# Marine Management Organisation

MMO Reference: DCO/2016/00004  
Planning Inspectorate Reference: EN010077  
Identification Number: 20024128

## **Planning Act 2008, Scottish Power Renewables, Proposed East Anglia One North (EA1N) Offshore Windfarm Order**

### **MMO Deadline 5 Response**

**Figure 1: ICES (2015 and 2016)**

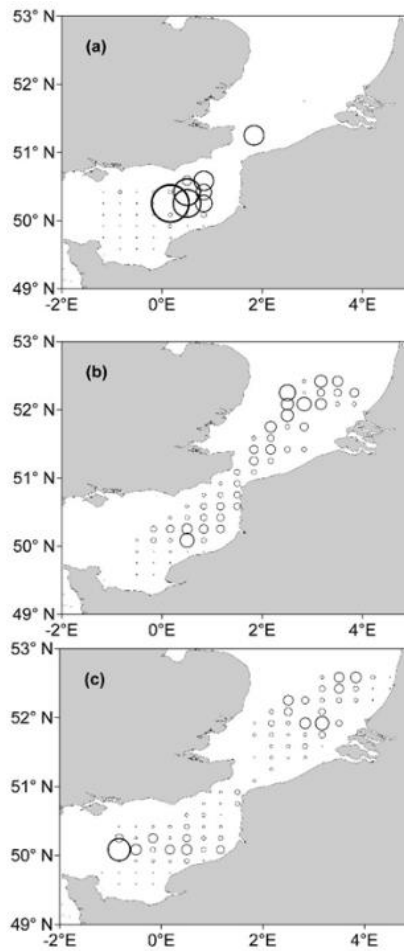
The MMO notes that the modelling presented in Figures 1 and 2 is based on a stationary receptor, using the maximum hammer energy. The MMO has assumed the hammer energy is 4000kJ though is not specified in the Applicant's response.

Figure 1. displays 10 years (2007-2017) of IHLS data for the two surveys undertaken during January each year (1-15 January and 16-31 January). Figure 2. displays 10 years (2007-2017) of IHLS data for the whole of the Downs survey period (16-31 December, 1-15 January, and 16-31 January).

Figures 1 and 2 show that there is an overlap of the noise contours for temporary threshold shift (TTS) and 150dB 'behavioural response' with northerly areas of the Downs herring spawning ground for EA2. The MMO notes for EA1N, there is a slight overlap of the TTS noise contour with the spawning ground, but as per EA2, the 150dB 'behavioural response' noise contour fully overlaps northerly areas of spawning ground.

In their current form, the maps presented in Figures 1 and 2 do not provide sufficient information to refine the period of temporal restriction. Within the ES and technical reports, the Applicant has presented a suite of maps including spawning and nursery ground maps, PSA data and IHLS data. Unfortunately, as the individual data sets have not been provided together in one map, it is difficult to interrogate and interpret to ascertain the level of potential risk to herring.

The style of 'heat map' used to present the IHLS data in Figures 1 and 2 is difficult to interpret, in terms of quantifying larval densities. It would be helpful if the IHLS heat map was presented using isopleths/contours with a colour graded key showing the different larval densities per  $m^2$  for each isopleth/contour.

- IHLS larval density data <11mm (newly hatched yolk sac larvae) for the 10-year data set in  $m^2$  (please see recommendations for presentation of IHLS data below).
- PSA data for the EA1N and EA2 study area (PSA data from the EA Zone would also be helpful)
- Seabed substrate British Geological Society (BGS) data with Folk (1954) classification.
- Historical herring spawning ground data (Coull et al., 1998)
- ICES rectangles
- TTS (186dB) noise contours
- 'Behavioural response' 150dB noise contours (as a substitute for 135 dB SEL<sub>ss</sub>)
